ULNRC-2546

CALLAWAY PLANT

RELAXED AXIAL OFFSET CONTROL

ATTACHMENT 1

AXIAL FLUX DIFFERENCE LIMITS AS A FUNCTION OF RATED THERMAL POWER FOR RAOC

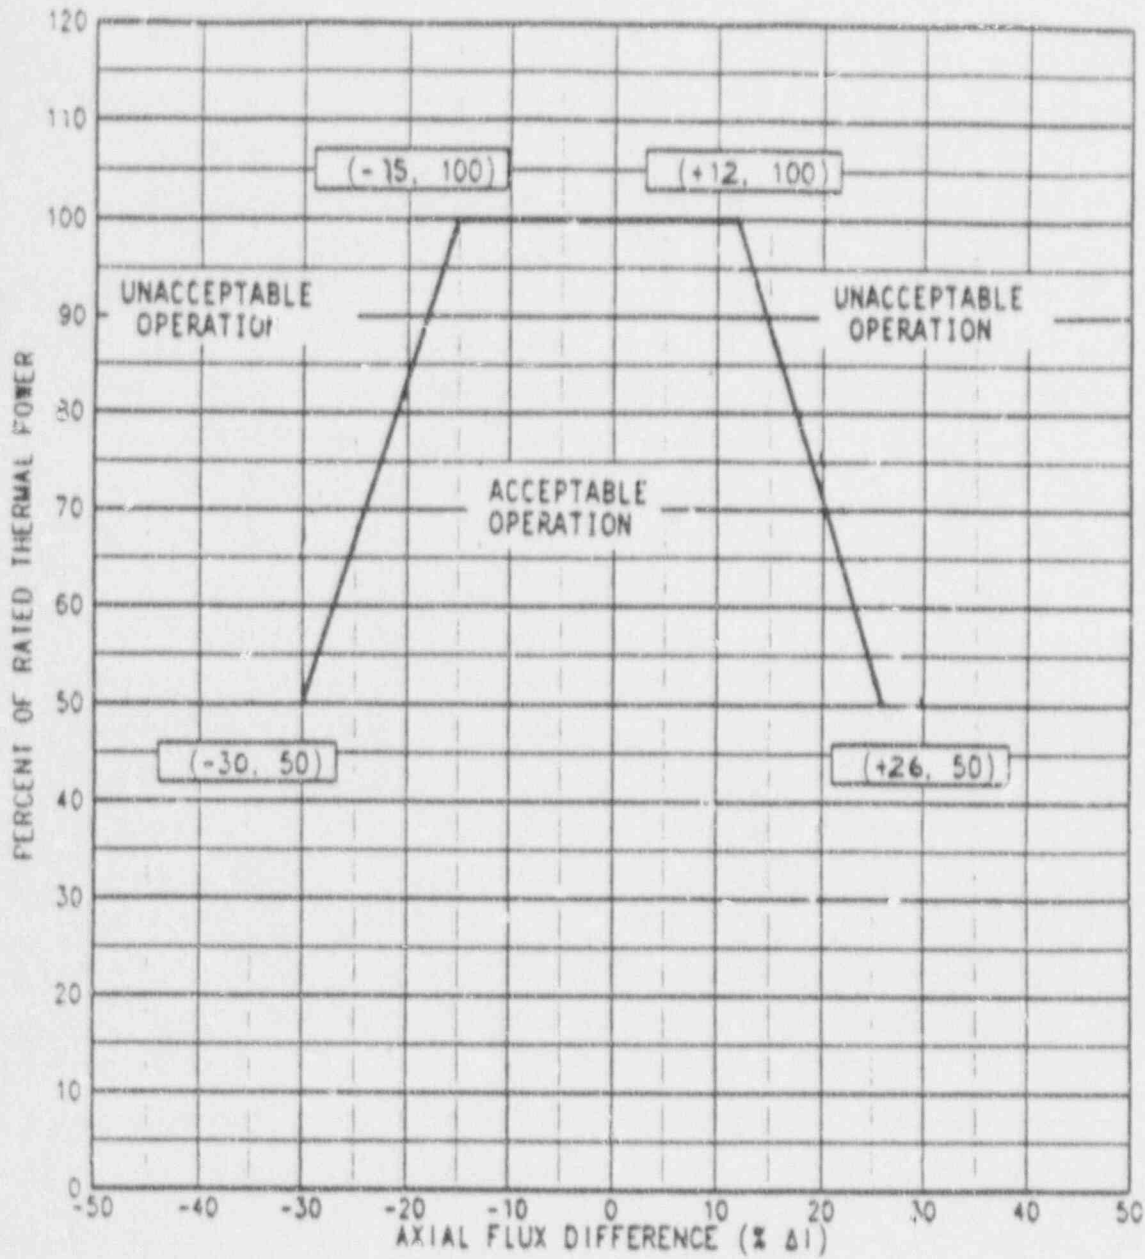
Because significant margin exists between the analytically determined maximum  $F_Q(z) * P_{rel}$  values and their limit, Restricted Axial Flux Difference (RAFDO) operation is not expected to be required for Cycle ~~5-6~~; this reason, no  $W(z)_{RAFDO}$  values are supplied for Cycle ~~5-6~~.

The Normal Operation  $W(z)$  values,  $W(z)_{NO}$ , have been determined for ~~three specific~~ *multiple* burnups in Cycle ~~5-6~~. This permits determination of  $W(z)$  at any cycle burnup through the use of ~~three point~~ interpolation. The  $W(z)_{NO}$  values were determined assuming ~~Cycle 5 operates with the CAC strategy, and uses a +3%, -12% delta-I band about the target flux difference.~~ Also included is a  $W(z)_{NO}$  function that bounds the  $W(z)_{NO}$  curve for all Cycle ~~5~~ burnups. Use of the  $W(z)_{NO}$  bounding curve will be conservative for any Cycle ~~5~~ burnup, however additional margin may

FIGURE 3

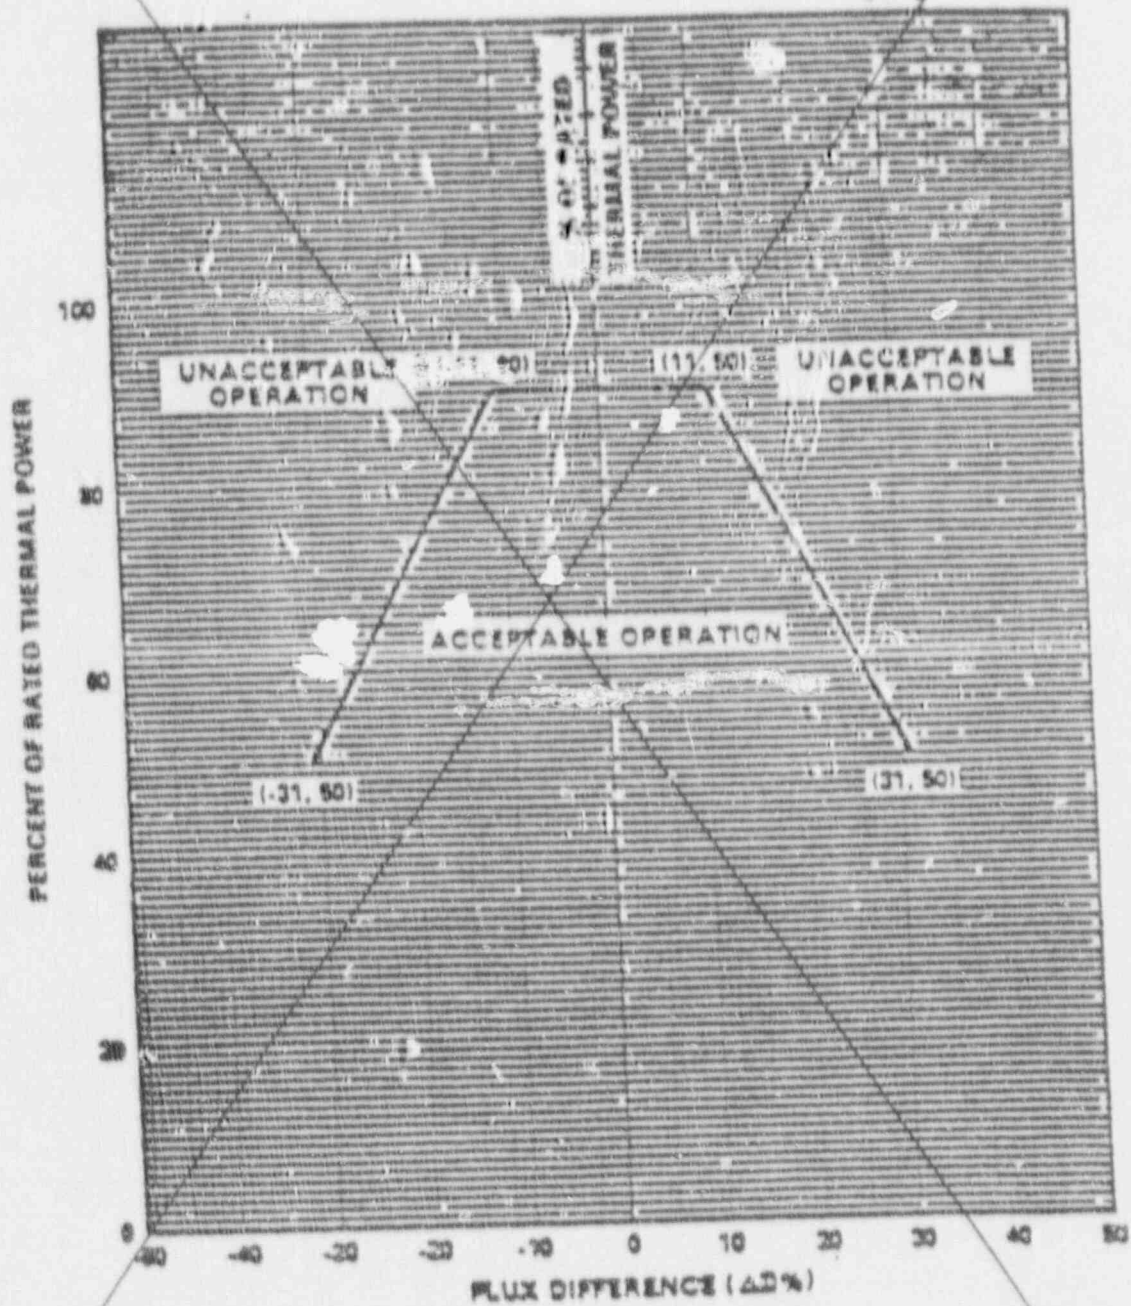
REPLACE WITH INSERT 2

AXIAL FLUX DIFFERENCE LIMITS AS A  
FUNCTION OF RATED THERMAL POWER

# INSERT 2
